FROM: Ryan Kump, P.E., City Engineer Ryan Kump

**SUBJECT:** Project Name: Clark Special Exception for Alteration of 30% Slope

Project Address: 3 Pepperwood Drive Project Number: SPX06032021-006063

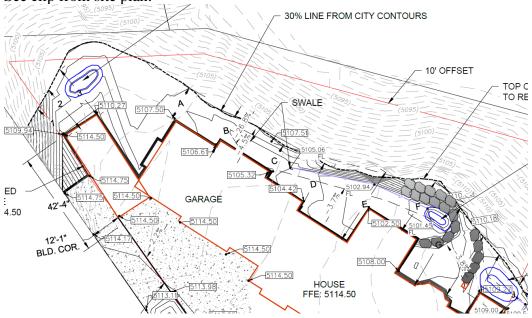
1. The preliminary site plan submitted on 12-31-2019 showed the crest of the slope restored vertically and horizontally with retaining walls and 4:1 (26%) downslope to the exposed basement level. See clip from site plan:

- 4. The final slope line was restored horizontally, but not vertically. Given the current construction and restoration efforts, it is determined the best course of action is to leave the top of slope line as-is. Attempting to restore the slope vertically would increase the steepness of hillside and require fill dirt. It will be difficult to structurally stabilize and restore vegetation. All existing revegetated slope would have to be removed and filled to obtain proper contours to the property line. It will increase probability of slope instability and storm water runoff problems. It is in the best interest of the city and landowner to maintain the slope as-is and allow the new vegetation to continue reestablishment.
